INTA	29 th GRSP	May 2001
	REGULATION ECE R14

Informal document N: 16
29th GRSP, May 2001.

**PROPOSAL FOR A CORRIGENDUM TO
DRAFT SUPPLEMENT N.2 TO THE REGULATION ECE R14.05.**

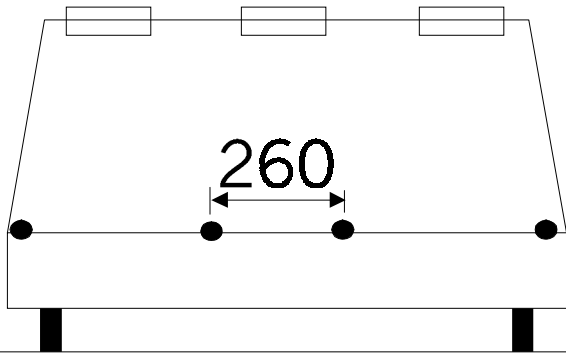
Paragraph 5.4.2.5: to be amended as follow.

- "... not less than 350 mm. For rear central seating positions of M1 or N1 vehicles, that distance may be not less than 240mm in case of bench seats, or individual seats provided that they may nor be interchanged with any seat located in an outboard position. The median longitudinal...." (see annexed drawing)
- Footnote: To be deleted.

DRAWING 1

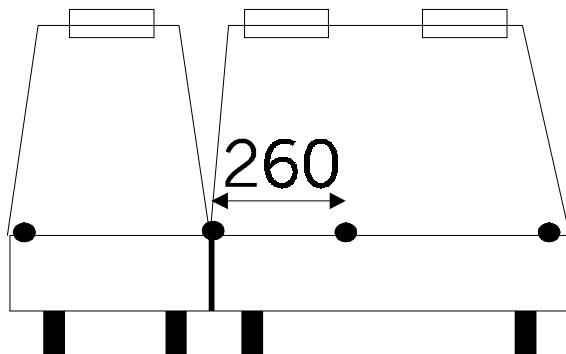
vehicle OK

DRAWING 2

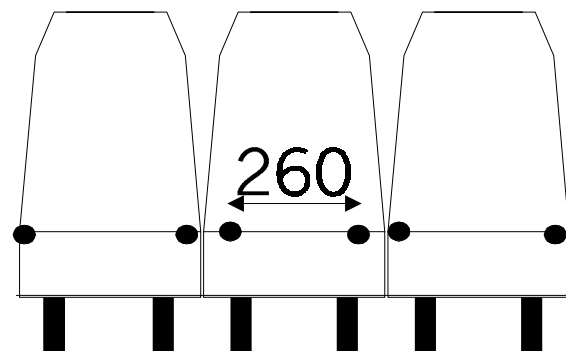
vehicle OK

DRAWING 3

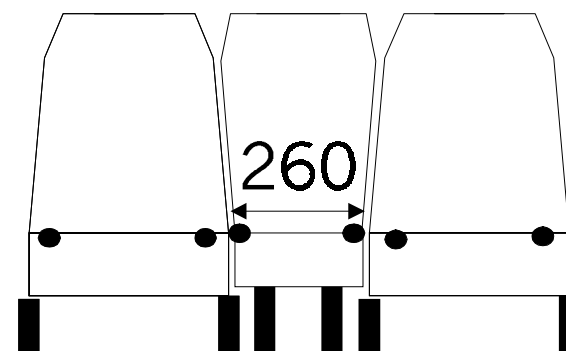
vehicle NOT OK
central seat
MAY BE
interchanged with
outboard seats
